ADDENDUM #04

Project Name: Central County Fire & Rescue House #06

Project Number: 24057

Date: July 20, 2026

A1 DIMENSION FLOOR PLAN
1/8" = 1'-0"

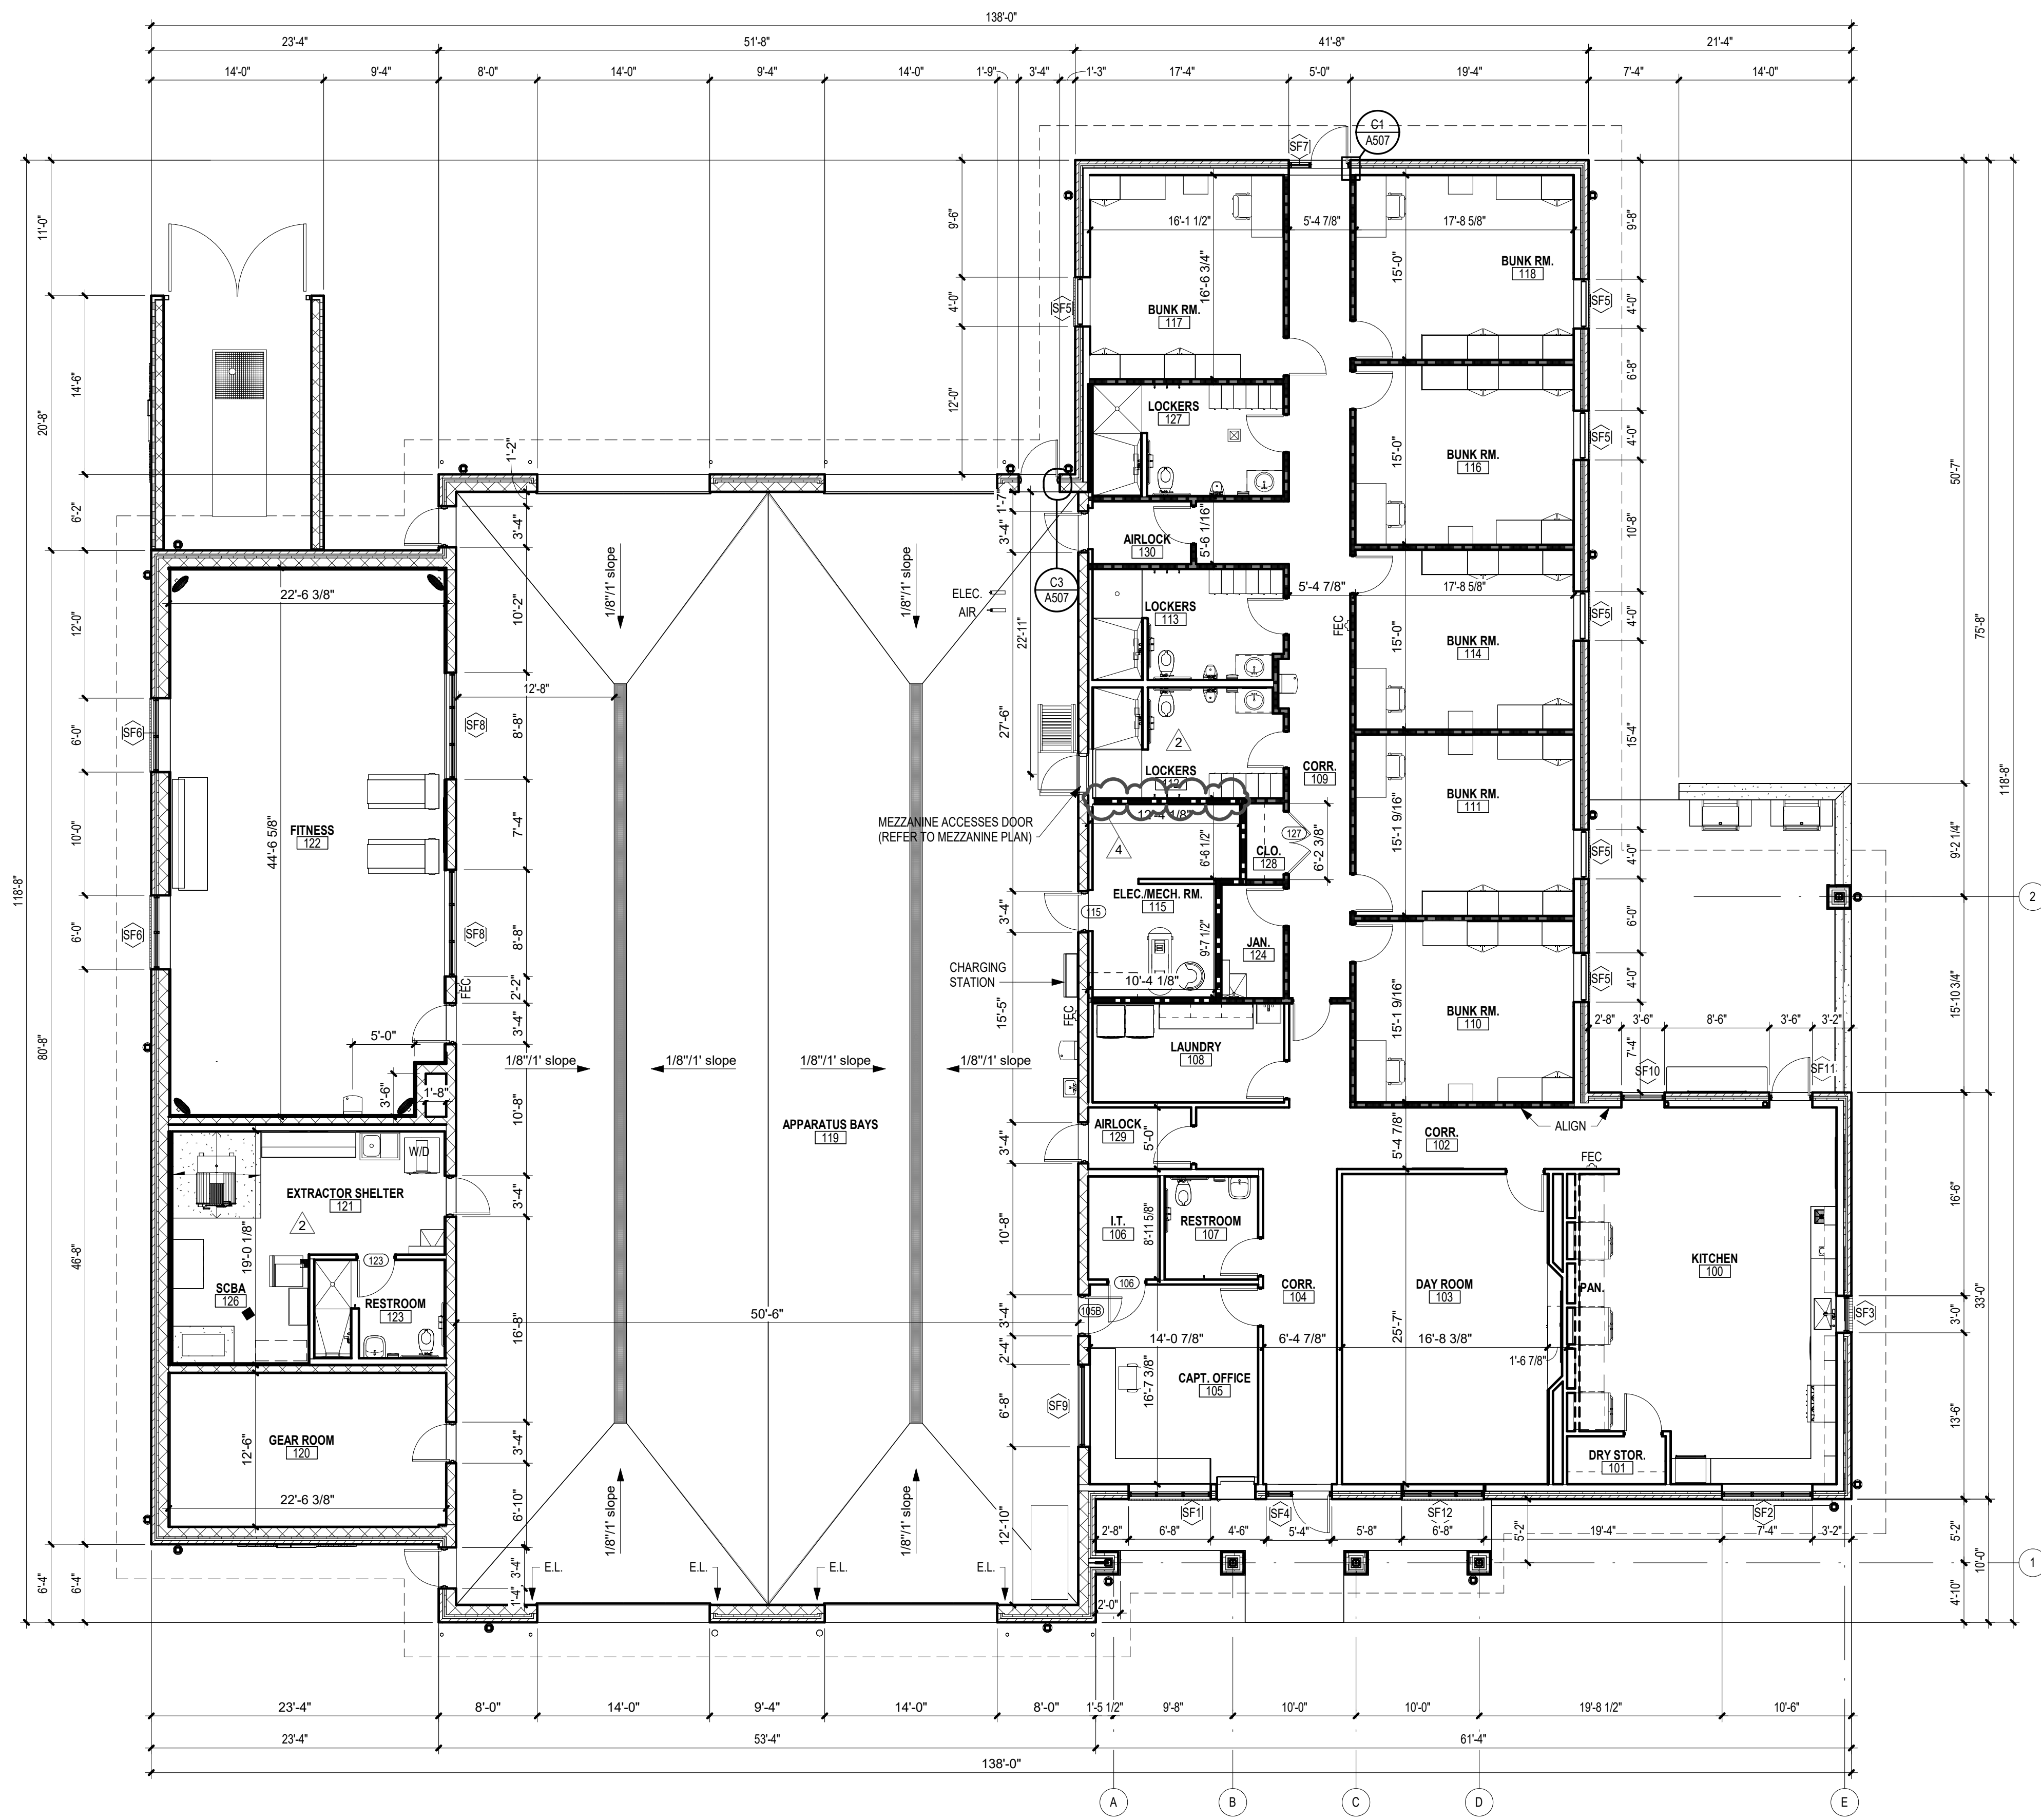
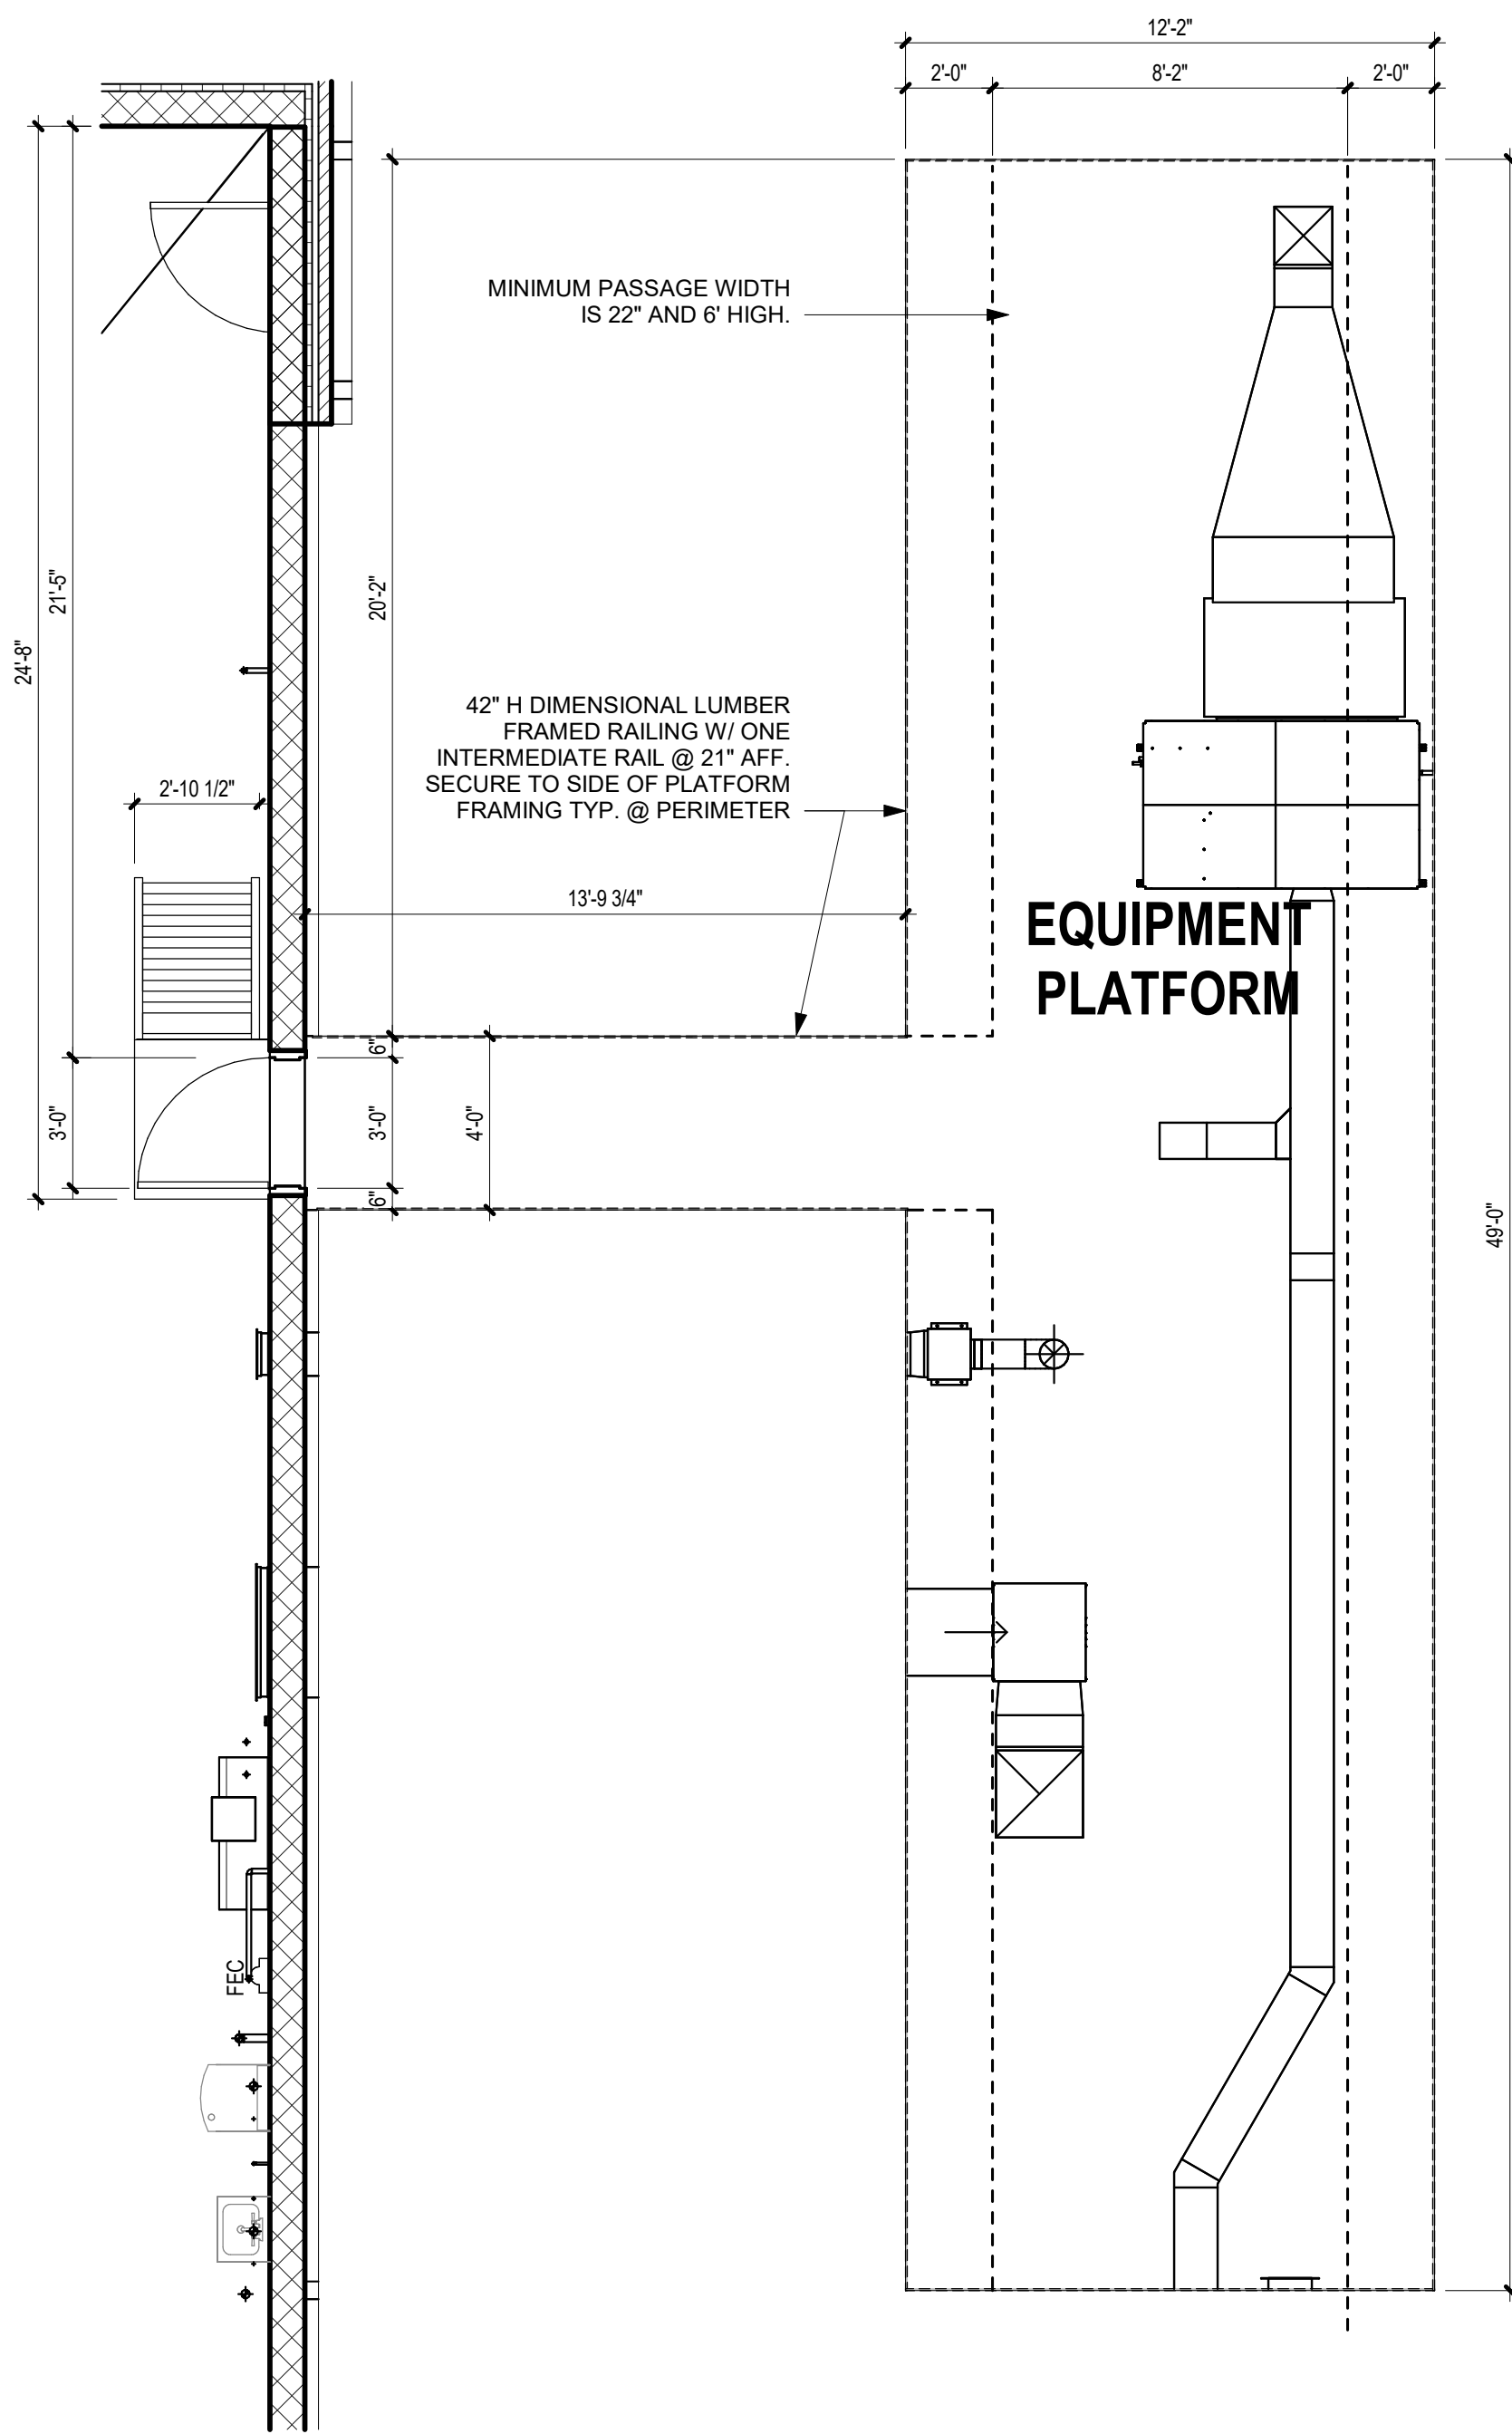
61. 1/S403 references a guardrail at the attic mechanical area and with a note that states "guardrail per architectural" , I cannot locate any details on these guardrails in the architectural drawings. Please provide railing details and attachment details.

- a. **Response: Railing construction narrative provided on drawing A6/A112.**

A1 FLOOR FINISH PLAN

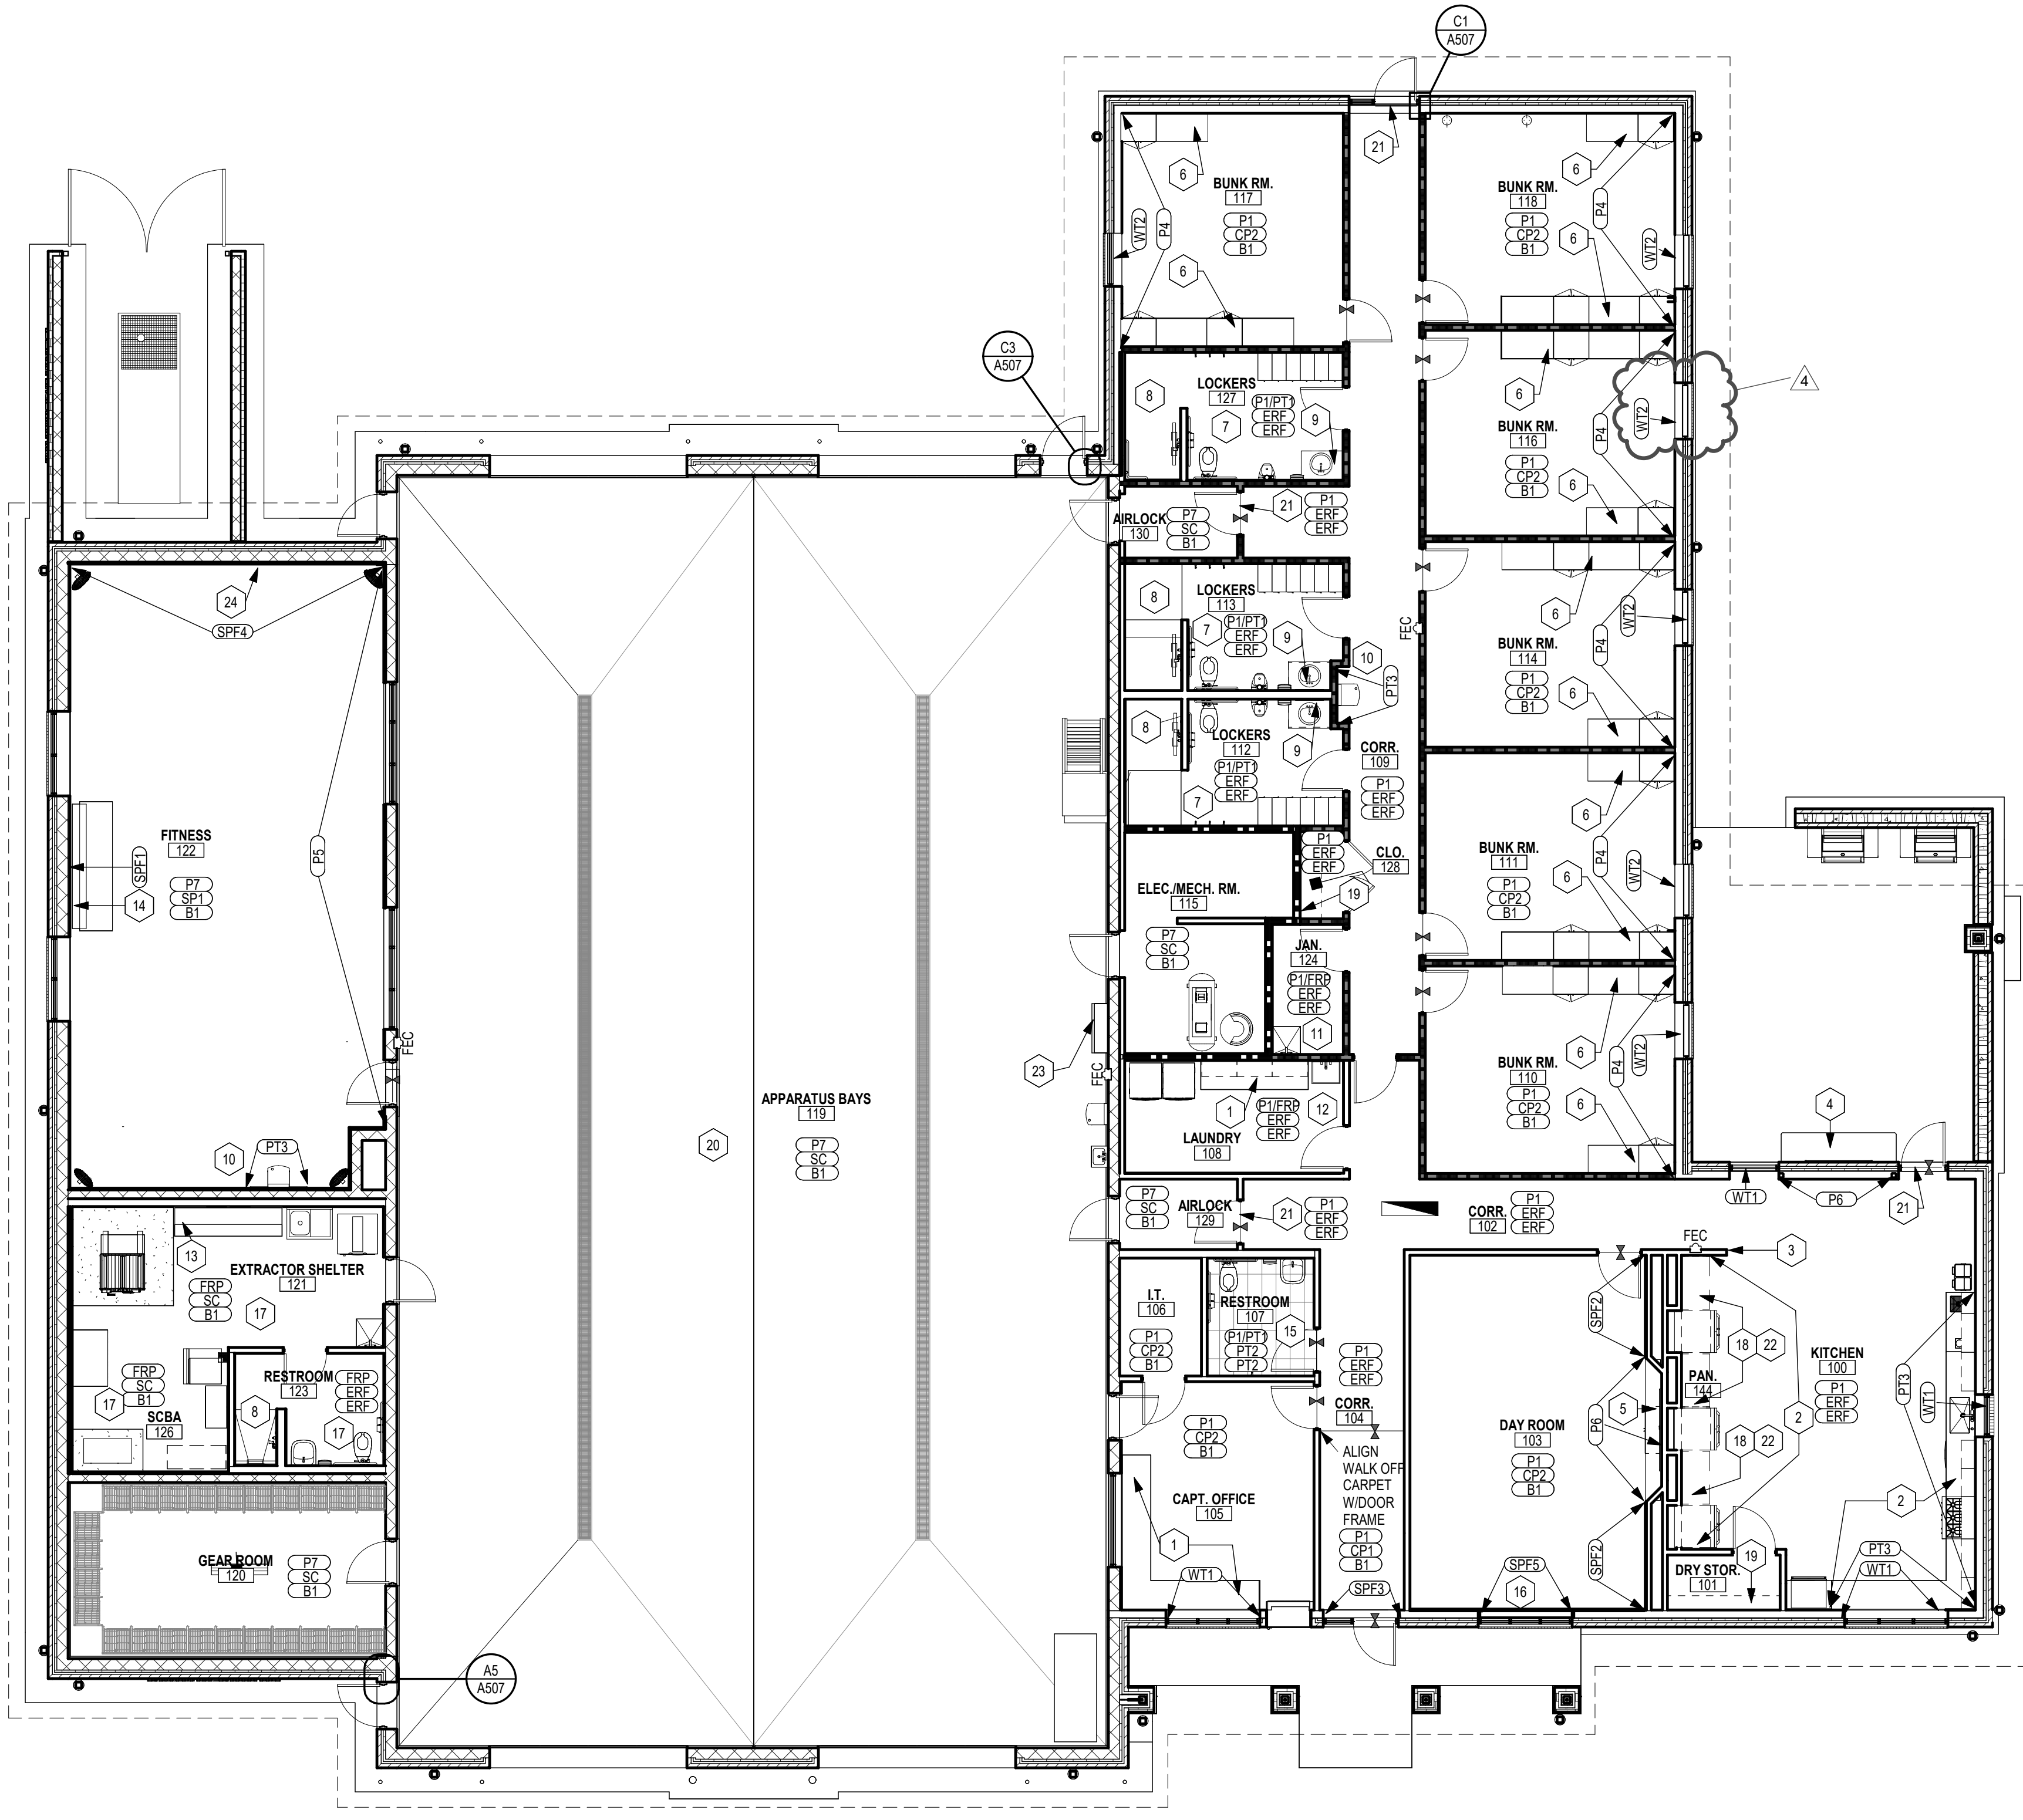
- 45. Bunk Room 116 has a "WT2" called out on I101, but there is no window present. All architectural drawings, such as A111, show a window in Bunk Room 116. Please verify if a WT2 window shade is needed in Bunk Room 116.

6. Sheet I101: Finish Floor Plan, Finish Sched.
 - a. Plans fixed to show window with sill tag
 - b. Reference attached Revised Sheet.

- a. **Response: Drawing corrected to show window.**
- 46. In response to RFI #48 in Addendum 02, is it true that there is no need for aggregate piers or other such additional supports because Structural has now coordinated and taken this into account?
